Amtex Ltd.

Structural Safety Inspection Report

Observations & Actions

Pakistan Accord Initial Safety Inspection Report

Figure 2.4 - Corrosion of Dowel reinforcement at roof of Building 01(Area 01)

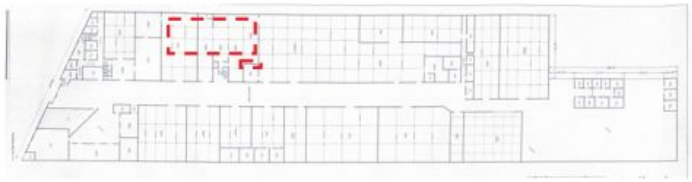
This observation is related to roof of building 01(Area 01) where the column rebars are exposed and inadequately protected against corrosion at roof floor. This presents a high risk of reinforcement corrosion, which may compromise the structural integrity overtime. F-202604-065746

Timeline	Remediation Plan
Longer Term CAP-0078154	Propose measures to prevent further water ingress and inspect damage to the columns dowels and propose appropriate repairs to structure
Longer Term CAP-0078155	Implement approved remedial measures

Figure 2.6 - Spalling Concrete at Roof of Building 01(Area 01)

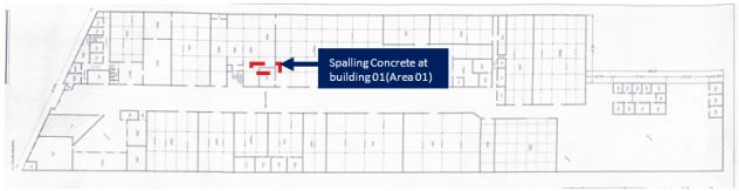
This issue refers to building 01 (Area 01) where spalling concrete in beam was observed. The cause of spalling is corrosion of reinforcement. The potential cause of corrosion of reinforcement is due to lack of waterproofing and exposed atmospheric weather condition. F-202605-066340

Timeline	Remediation Plan
Medium Term CAP-0079200	Inspect damage to the beam and propose repair to the structure. Submit report capturing above to Pakistan Accord for approval.
Longer Term CAP-0079201	Implement remedial works
Longer Term CAP-0079245	Continue to monitor for future signs of damage.

Figure 2.11 - Lack of edge protection at building 02

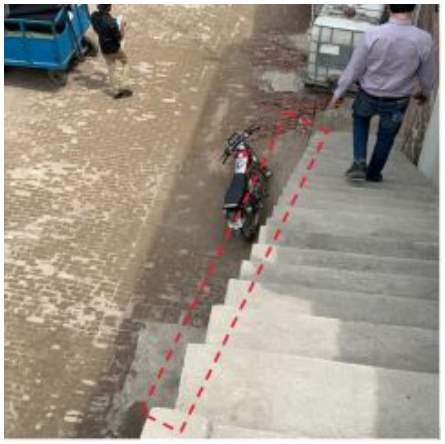
This issue is related to roof and staircase of building 02 where there is no edge protection leaving open edges without proper guardrails or barriers. This creates a serious fall hazard for anyone working or walking near the roof edge. F-202604-065735

Timeline	Remediation Plan
Immediate CAP-0078129	Provide adequate edge protection on the roof, staircase and on any other part of the factory with the same issue.
